NARRABRI GAS PROJECT

Produced Water Management Plan

0041-150-PLA-0018

Produced Water Management Plan – NRAR comments received on Revision C (draft)

Figure 4.1 - Predicted existing and produced water production in Phase 1

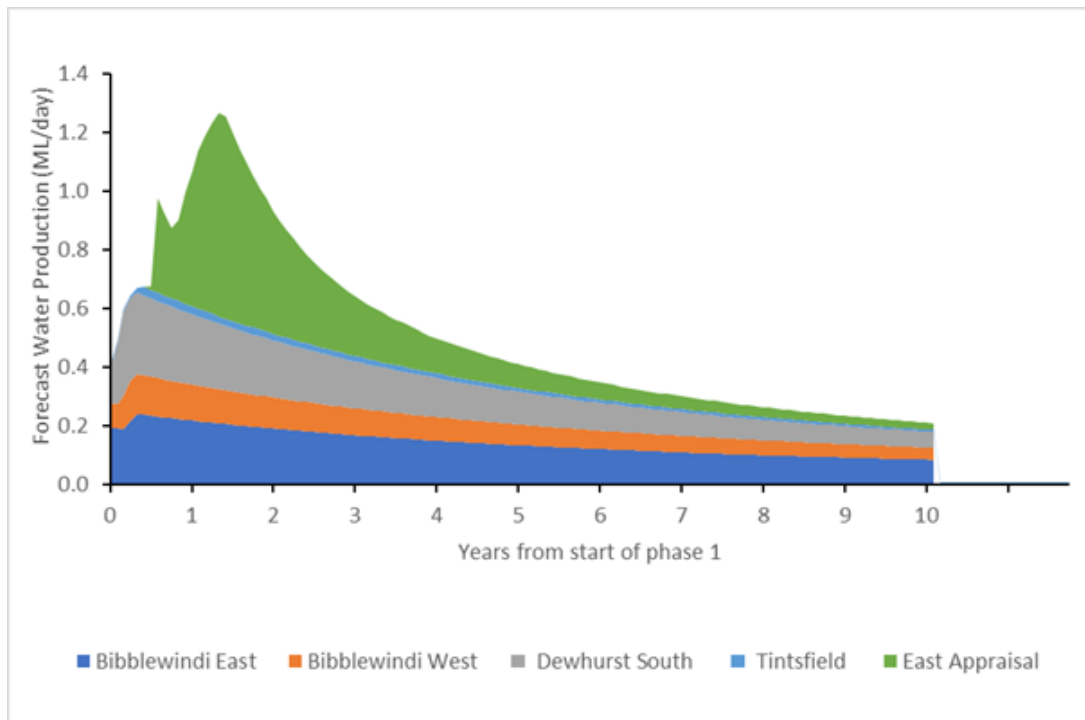
- In Section 4.2 of the Produced Water Management Plan it is noted 1.26ML/d of produced water is predicted from operation of the existing and proposed pilot wells. It is recommended a reference be included to how this water take is to be accounted for by inclusion of relevant Water Access Licence numbers and entitlement, and relevant linked Work Approval/Miscellaneous Work numbers.

Item	Section #	Section heading	Existing text	Comment	Final response
1	4.2	Produced water quantity	The estimated quantity of produced water associated with the Phase 1 activities, including the operation of the existing pilots for exploration and appraisal activities in PEL 238 and PAL 2 is up to approximately 1.26 ML/day. Further details are provided in the Site Water Balance	It is noted 1.26ML/d of produced water is predicted from operation of the existing and proposed pilot wells. It is recommended a reference be included to how this water take is to be accounted for by inclusion of relevant Water Access Licence numbers and entitlement, and relevant linked Work Approval / Miscellaneous Work numbers	Section 4 of the Site Water Balance provides full details on the water access licences and water supply works for direct and indirect water take.
